ENCLOSURE 5

CHANGES TO UNIT 2 AMENDMENT NUMBER 127 AND UNIT 3 AMENDMENT NUMBER 116
TECHNICAL SPECIFICATION AND BASES PAGES FOR PROPOSED CHANGE NUMBER 418

This change adds a new section to the Technical Specifications: Section 3.7.7.1, Component Cooling Water (CCW) Safety Related Makeup System. New Technical Specification and Bases pages for Section 3.7.7.1 are attached. Changes to the Technical Specification Table of Contents which reflect the new section are also attached and highlighted appropriately. The following summarizes the changes.

Figure 3.7.7.1-1

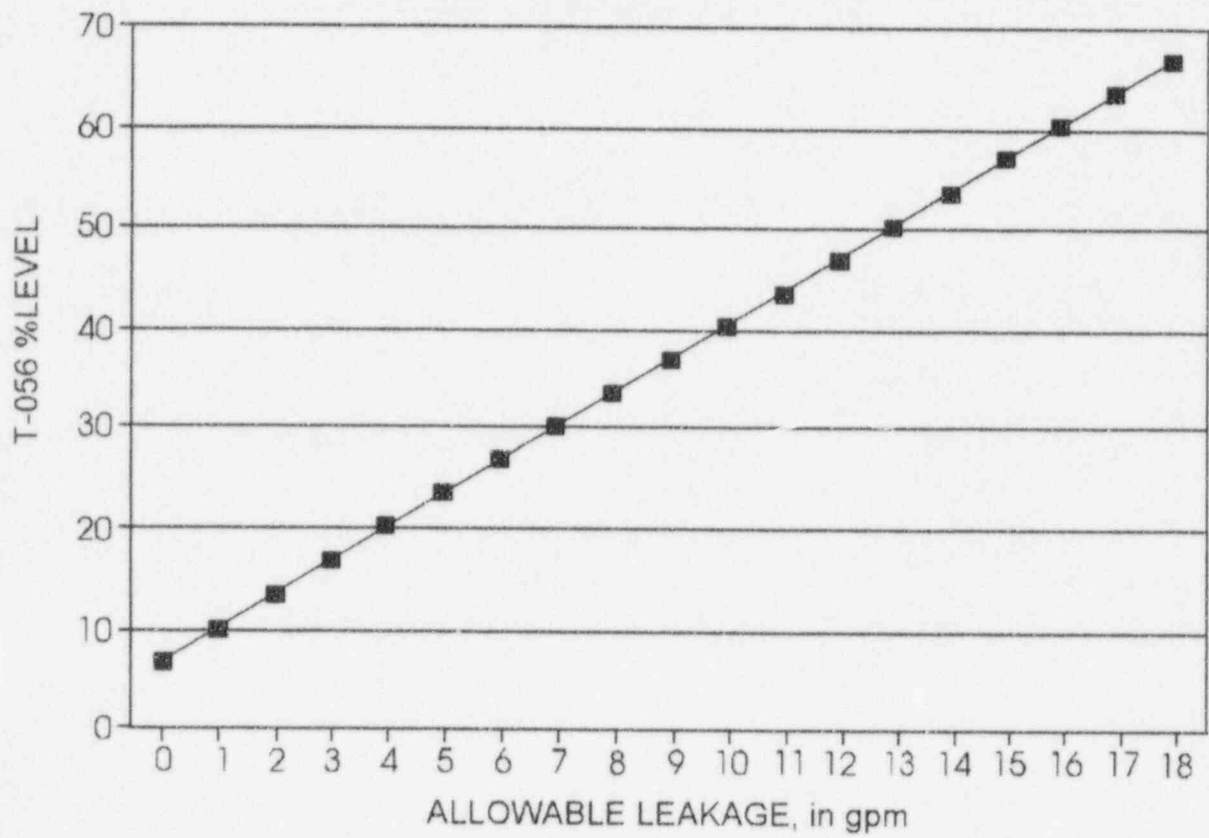
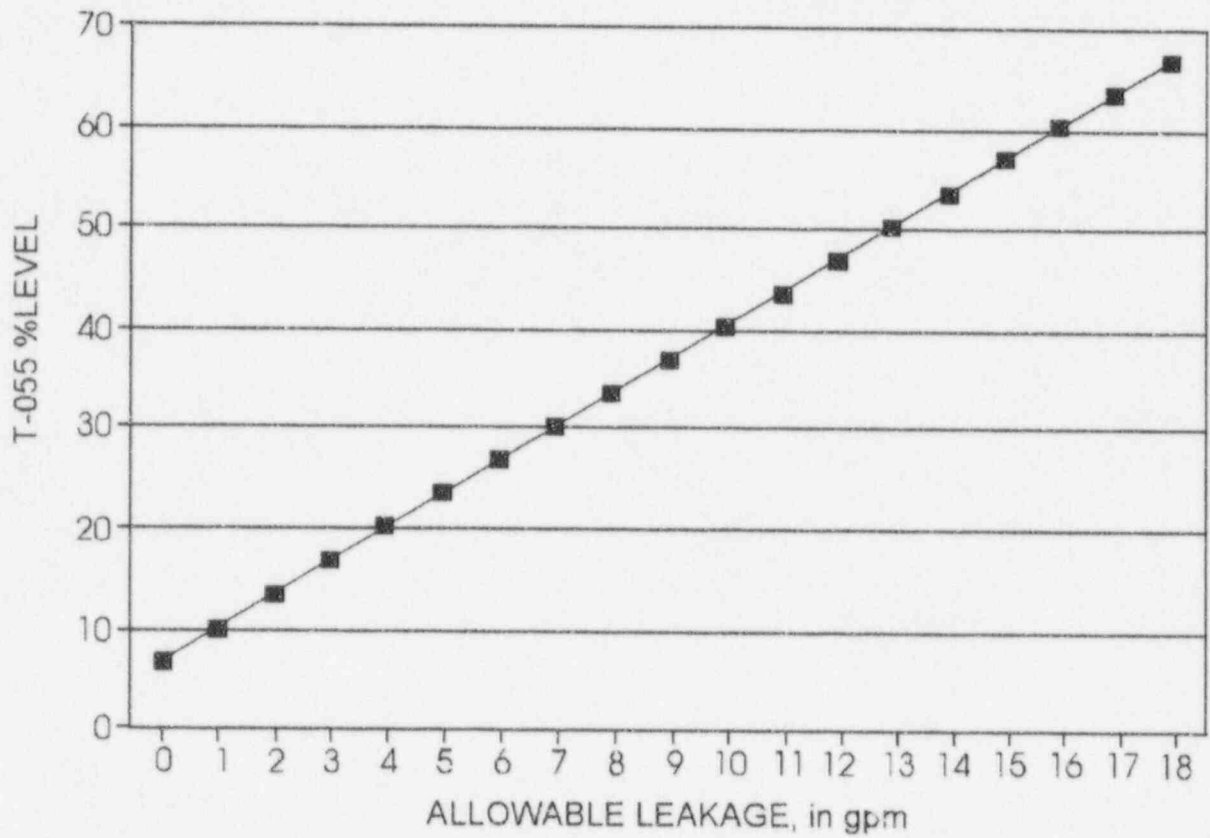
Operating experience shows that the likelihood of Primary Plant Makeup Storage Tank level dropping below 66% (which corresponds to an allowable CCW leakage of 18 gpm based on Figure 3.7.7.1-1) is extremely low. Also, a Probabilistic Risk Assessment (PRA) was performed to assess the increased risk of core damage from an 8 hour allowed outage time for two trains of the CCW Safety Related Makeup System. The PRA indicated that the increased risk of core damage from an 8 hour allowed outage time is less than 1×10^{-6} per year. This increase in core damage risk is considered acceptably small.

LCO 3.7.7.1 Two trains of Component Cooling Water (CCW) Safety Related Makeup System shall be OPERABLE with a contained volume in the Primary Plant Makeup Storage Tank \geq the level specified in Figure 3.7.7.1-1.

| CONDITION | REQUIRED ACTION | COMPLETION TIME |
|--|--|--|
| B. Two CCW Safety Related Makeup flow paths inoperable. <u>OR/AND</u> The Primary Plant Makeup Storage Tank Level < that required by Figure 3.7.7.1-1. | B.1 Restore one CCW Safety Related Makeup flow path to OPERABLE status. <u>AND</u> B.2 Restore the Primary Plant Makeup Storage Tank Level to OPERABLE status. | 8 hours (continued) |

This SURVEILLANCE REQUIREMENT measures CCW leakage to ensure the PPMU Tank level is adequate in accordance with Figure 3.7.7.1-1. The specified frequency is considered adequate in view of the special alignment required to perform this test. This measurement can be performed only when one CCW critical loop can be removed from service. Therefore, this measurement needs to be performed during refueling outages.

This SURVEILLANCE REQUIREMENT measures CCW leakage to ensure the PPMU Tank level is adequate in accordance with Figure 3.7.7.1-1. The specified frequency is considered adequate in view of the special alignment required to perform this test. This measurement can be performed only when one CCW critical loop can be removed from service. Therefore, this measurement needs to be performed during refueling outages.
